Re: Chobani Processing Plant, Griffiss Technology Park
Staff Review of Submitted Site Plan

Review memo dated May 2, 2025

Review Memo dated May 8, 2025

C400-00
PROJECT SITE LAYOUT PLAN
1" = 100'

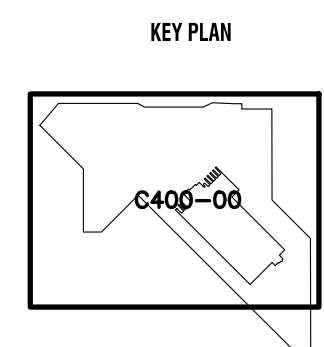
13. We recommend that the sidewalk shown on Sheet C400 of the revised plans be changed to a 10'-12' shared-use path to match the existing Griffiss Sculpture Garden Trail that runs along State Route 825. It is anticipated that improvements to Perimeter Road will be designed similarly, and this will provide a safe, convenient multi-use connection between the proposed facility and the surrounding community. Usage for the shared-use path located on the Mohawk River Trail just south of the Route 825 parking area recorded an average monthly user count of 5,000 people, with peak monthly usage in September 2024 of 8,500 people.

The sidewalk has been revised to a multi-purpose path with a 12-foot width.

C710-00-0
DETAILED LANDSCAPING PLAN
1" = 40'

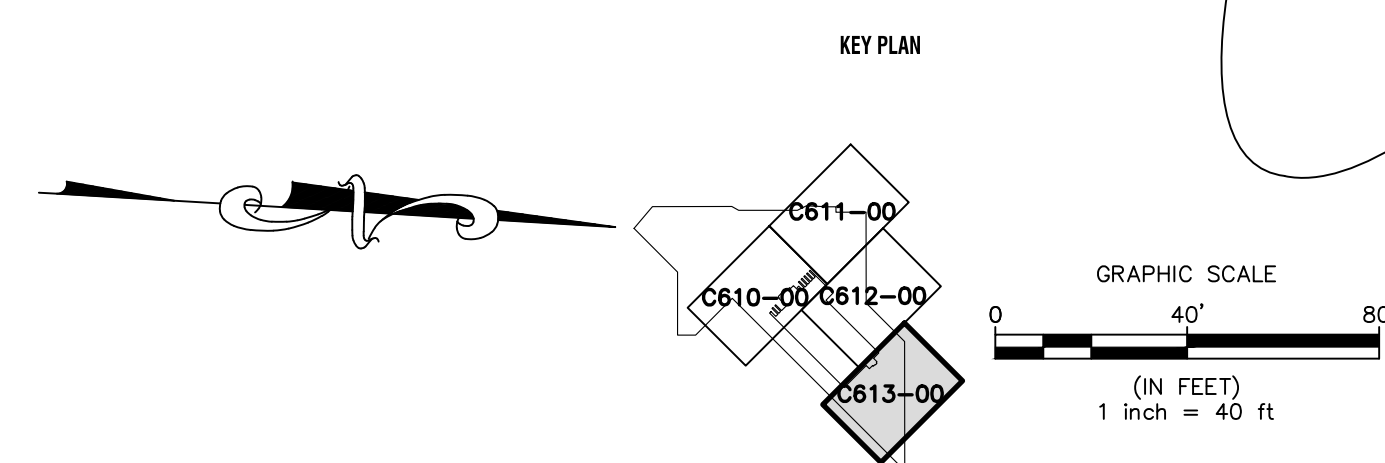
9. Per Section 80-15.3(b), a maintenance agreement describing landscaping responsibilities is required. For the purposes of this application, it will be sufficient to add a note to the applicable sheets within the site plan packaged identifying who will be responsible for landscape maintenance (property owner or lessee) and whether it will be performed by contract or “in-house”.

10. Per Section 80-15.4(b), coniferous trees must be at least six feet in height at time of planting. Sheet C700-00-0 lists planting heights of five foot for the proposed evergreens. Please revise in the next revision of the site plan package.

A general maintenance agreement has been added to the notes on sheets C700-00 & C710-00 describing the lessee as responsible for ongoing landscaping maintenance.

The planting height for coniferous trees has been updated to 6 feet on sheets C700-00 & C710-00.
